ORDER OF ADOPTION

Rule No.: Chapters ILHR 50 - 64

Relating to: Miscellaneous Changes to the Commercial Building Code

Clearinghouse Rule No.: 93-8

SECTION 235. ILHR 50 to 64 Appendix Section A-51.01 (115) is repealed and recreated to read:

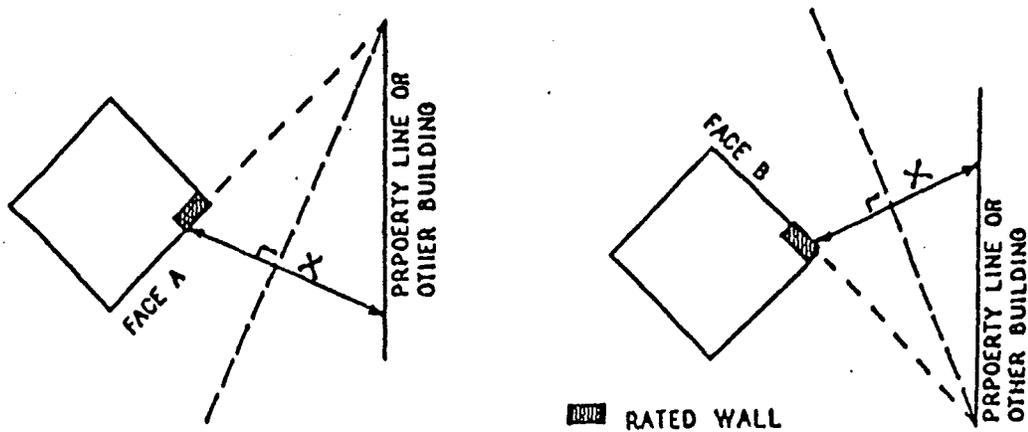
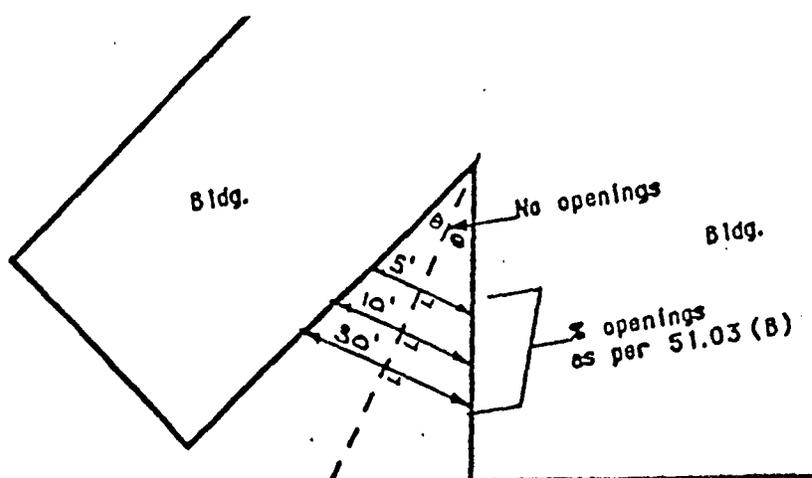
A-51.01 (115) SETBACK. The intent was to not include gutters, downspouts, outdoor lighting fixtures, signs and similar attachments as part of a building.

To determine the portion of a wall (A) that is within a distance X from a property line or another building, extend the wall face to its intersection with the property line or other building. Bisect the angle formed by the intersection. Measure X perpendicular to the bisector. Repeat these steps for wall face B.

The following sketch shows setback measurements between intersecting or projected intersection of building faces.

SECTION 236. ILHR 50 to 64 Appendix Section A-51.152 is created to read:

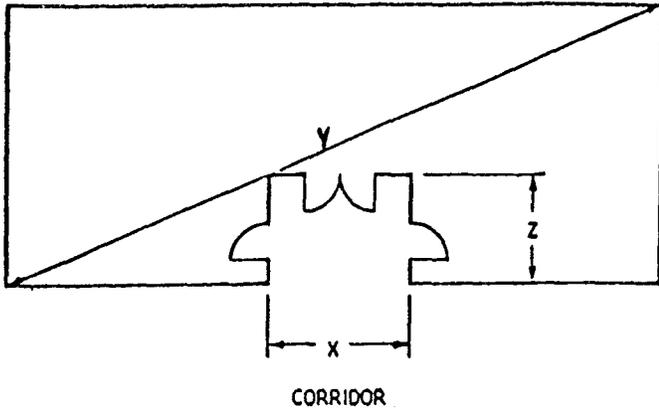
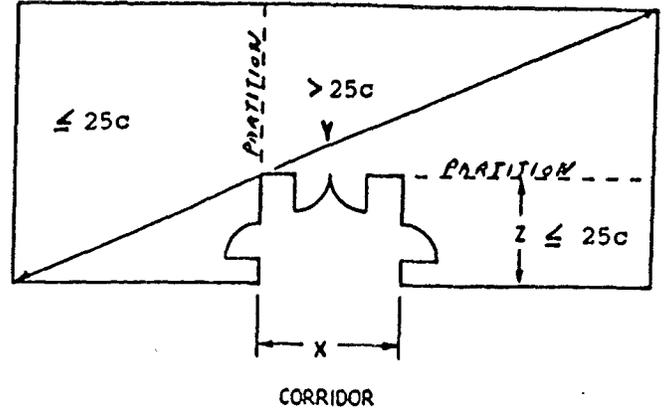
A-51.152 EGRESS CONFIGURATIONS. The following diagrams are provided to aid building designers in determining proper egress configurations:

$$20' \leq x \leq \frac{y}{2}$$

$$20' \leq x \leq \frac{y}{2}$$
